Hilfield Solar Farm and Battery Storage Facility

Statement of Common Ground - Noise

LPA Reference: 21/0050/FULEI (Hertsmere Borough Council)

RE: Hilfield Solar Farm. Additional Information re Noise.

FIGURE 1: R1 AERIAL VIEW

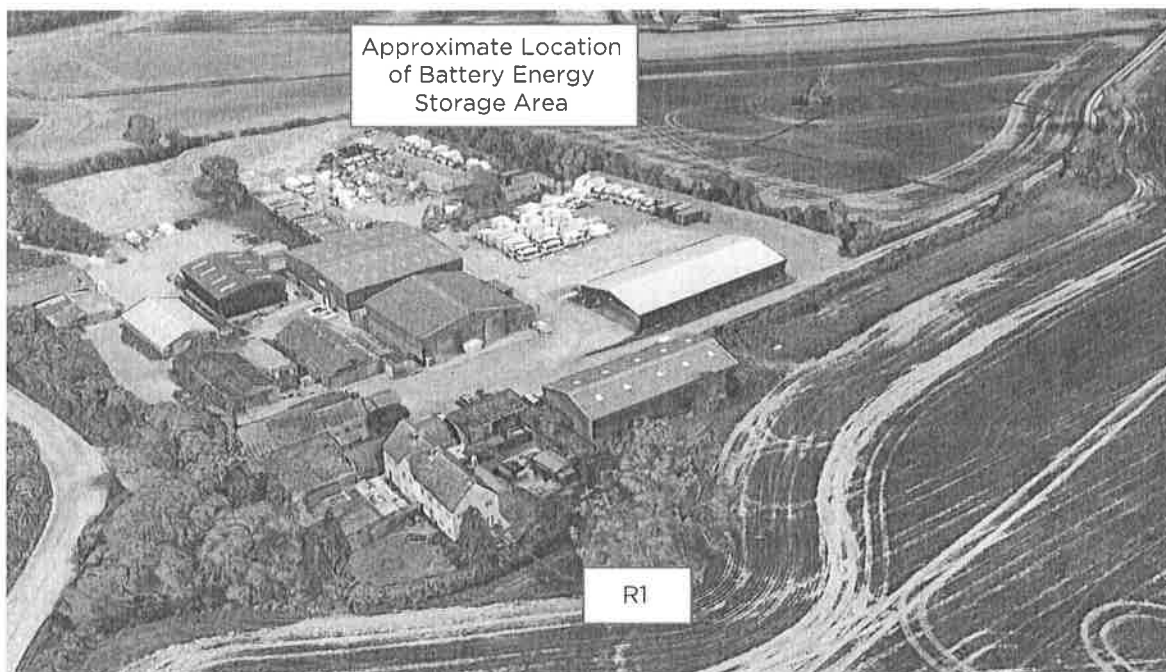
As discussed in our telephone call, the receptor R1 is heavily screened by the built form of adjacent commercial buildings, as shown in Figure 1, below. The centre of the battery energy storage area is some 170 m from R1.

Using iNoise, we have extracted the source to receiver attenuation factors, calculated in accordance with ISO 9613, to enable the verification of the calculations. The battery energy storage area was modelled as a single point source, with appropriate corrections made for the quantity of HVAC fans etc.

The specific sound level at R1, from the battery energy storage at a height of 1.5 m above ground level, is therefore 16.6 dB.

The net effect of removing the screening from the calculations increases the predicted specific sound level at R1 from the battery energy storage area by some 13.2 dB.

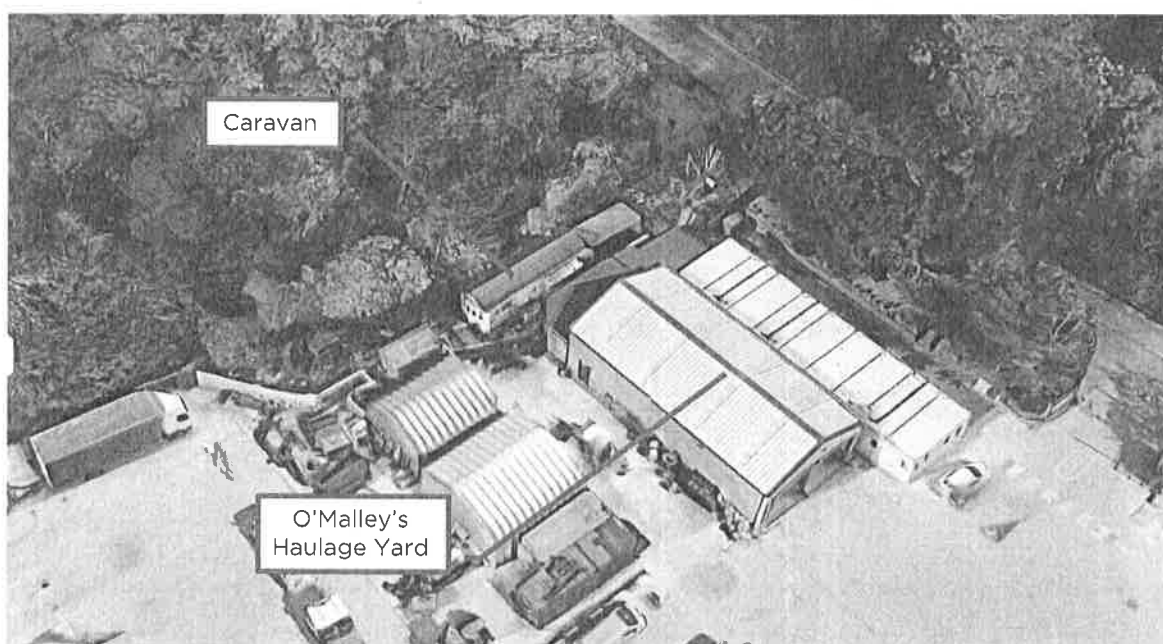
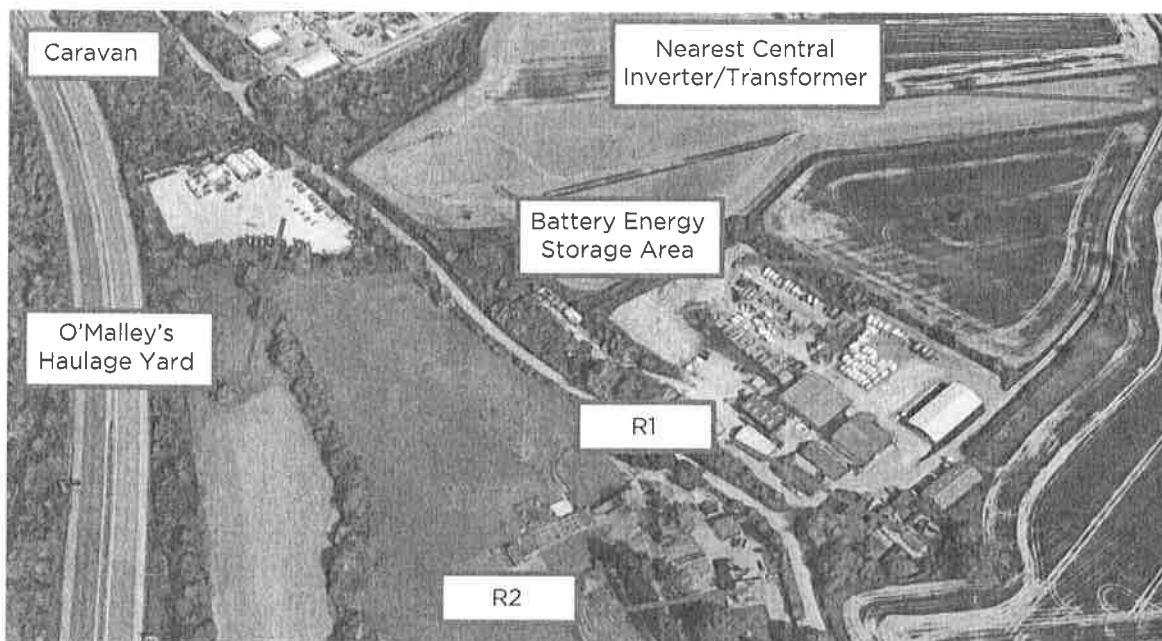
I understand that the caravan located to the rear of O'Malley's Haulage Yard was raised on the first day of the Public Inquiry, and a query was raised as to why this was not included in the noise assessment. I have elaborated on this point in the following text.

Please find attached a 3D aerial view of the caravan in question, relative to the proposed noise generating elements of the proposed development (battery energy storage area and central inverter/transformer stations). I appreciate the solar panels do encroach much further towards the caravan, but do not inherently generate any noise.

The caravan is screened by the built form of O'Malley's Haulage Yard, and the highest calculated rating sound level at the caravan is 25dB at a height of 1.5 m (as it is single storey unit), some 33dB below the daytime background noise level, and 26dB below the night time noise level. The caravan is in very close proximity to the M1, so the measurement position MP6 has been used to represent the background sound level at this property.

The margin of compliance is same as that demonstrated at R8 in the noise assessment report, i.e. this would be one of the least potentially affected receptors in the entire vicinity of the proposed development, and is therefore not a constraint with respect to noise, hence why it was not considered in the initial noise assessment.
